**TOWN OF LOS GATOS
PLANNING COMMISSION
REPORT**

DATE: March 21, 2025
TO: Planning Commission
FROM: Joel Paulson, Community Development Director
SUBJECT: Consider a Request for Approval to Demolish Existing Commercial Structures, Construct a Mixed-Use Development (30 Multi-Family Residential Units) with Commercial Space on the Ground Floor, a Conditional Use Permit, a Condominium Vesting Tentative Map, and Remove Large Protected Trees Under Senate Bill 330 (SB 330) on Property Zoned C-2. **Located at 143 and 151 E. Main Street.** APNs 529-28-001 and -002. Architecture and Site Application S-24-007, Conditional Use Permit Application U-24-002, Vesting Tentative Map Application M-24-004, and Mitigated Negative Declaration Application ND-24-003. An Initial Study and Mitigated Negative Declaration Have Been Prepared. Property Owner: David Blatt, CSPN LLC. Applicant: Kenneth Rodrigues and Partners, Inc. Project Planner: Ryan Safty.

Consider a request for approval to demolish existing commercial structures, construct a mixed-use development (30 multi-family residential units) with commercial space on the ground floor, a Conditional Use Permit, a condominium Vesting Tentative Map, and r

PROPOSED REAR FACADE

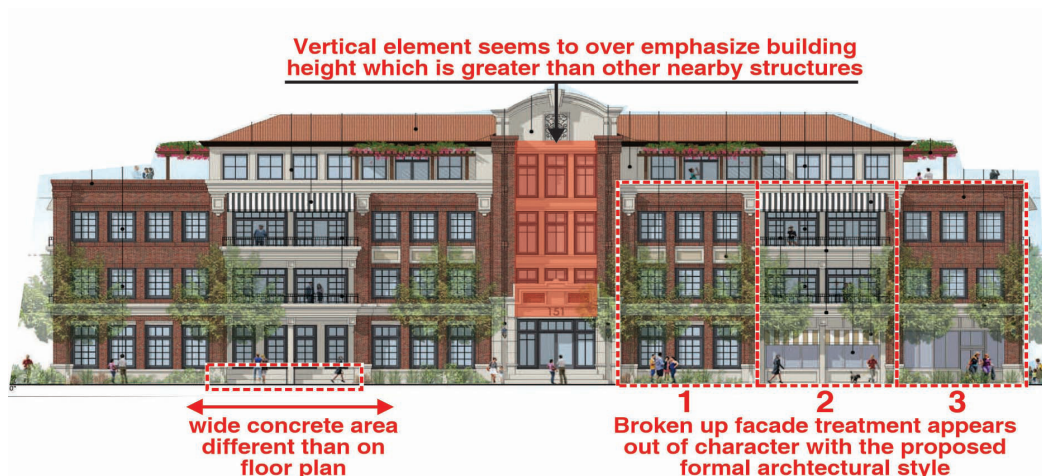
ISSUES AND CONCERNS

The proposed building is much taller than the preponderance of structures in the site's immediate context, but the presence of the adjacent high school main building provides some height transition for a taller structure here. Overall the design is well done but there are a few refinements that I would recommend to enhance its compatibility with its neighbors.

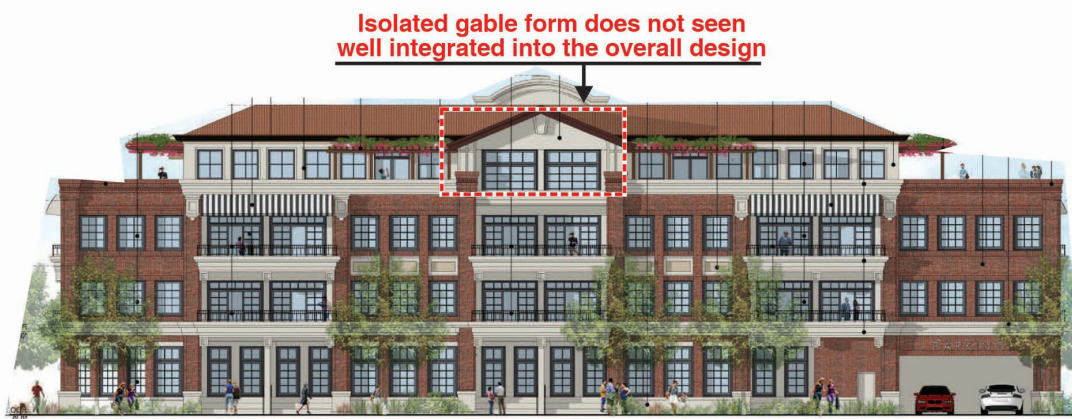
Both side facades appear very different from front and rear facades

Both side facades appear very different from front and rear facades

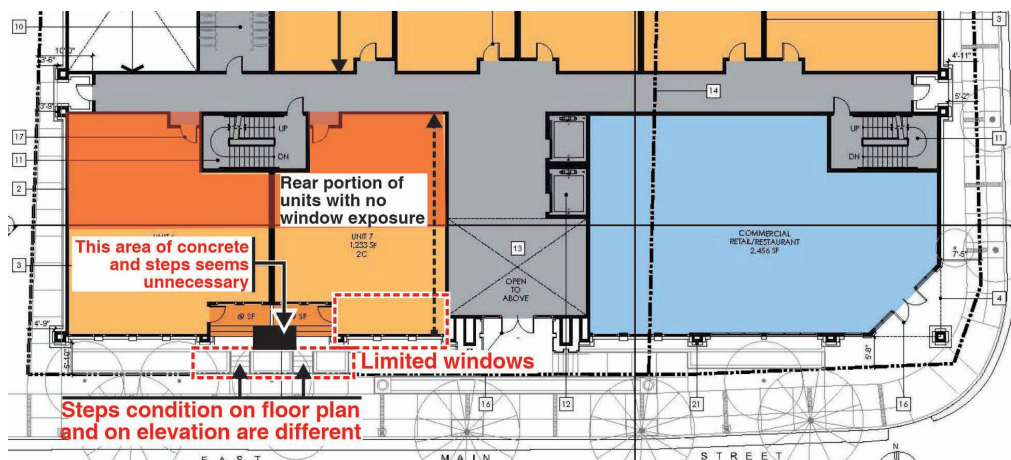
4. The central gable roof on the rear facade is a form not found elsewhere on the building and seems out of place in the overall unity of the design.

Isolated gable form does not seem well integrated into the overall design

4. Modify the gable roof form on the rear facade to blend in better with the overall building design.

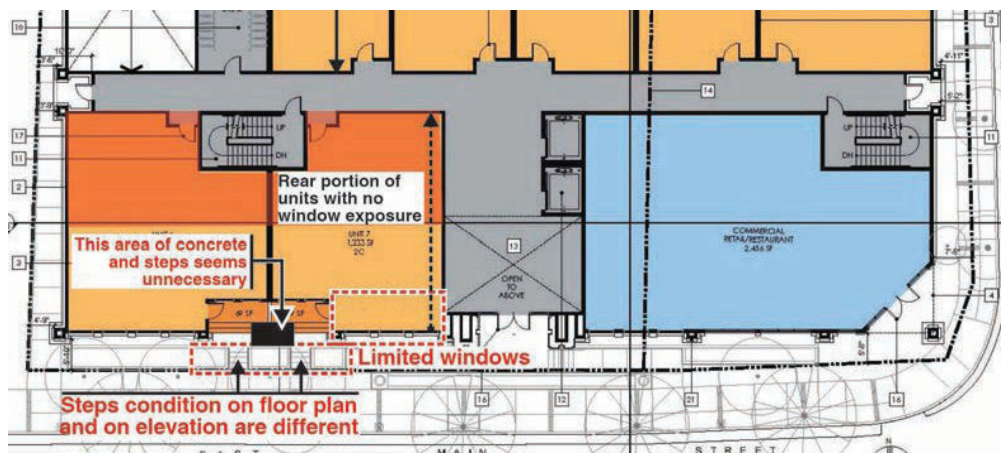
Both side facades appear very different from front and rear facades

Both side facades appear very different from front and rear facades

4. The central gable roof on the rear facade is a form not found elsewhere on the building and seems out of place in the overall unity of the design.

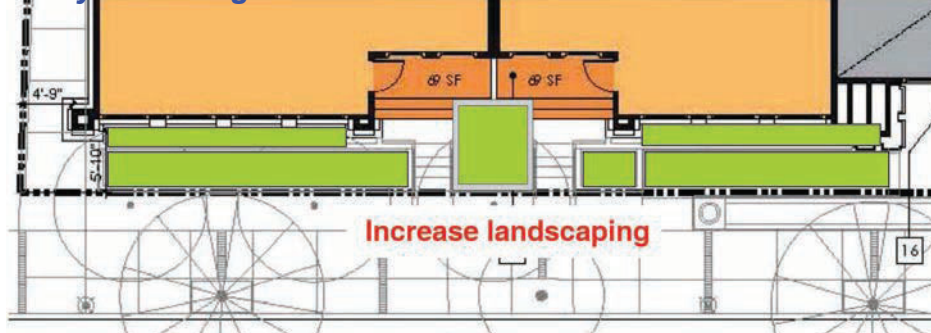
1. Maximize the amount of landscaping along the East Main Street frontage. One example of a similar patio entry along the sidewalk is shown in the photo below.

Currently reviewing this comment.

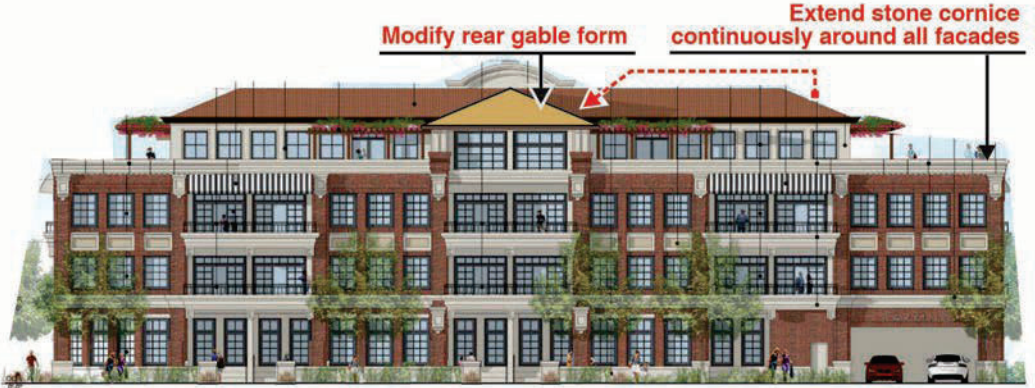
2. Extend the stone cornice and decorative stone work consistently around all sides of the building.

3. Add brick spandrel infill on the four story tall wall over the primary East Main Street entry to reduce its vertical emphasis.

Completed. See Sheets A3.0 and A3.1.

We will not be adding this proposed change to the design drawings.
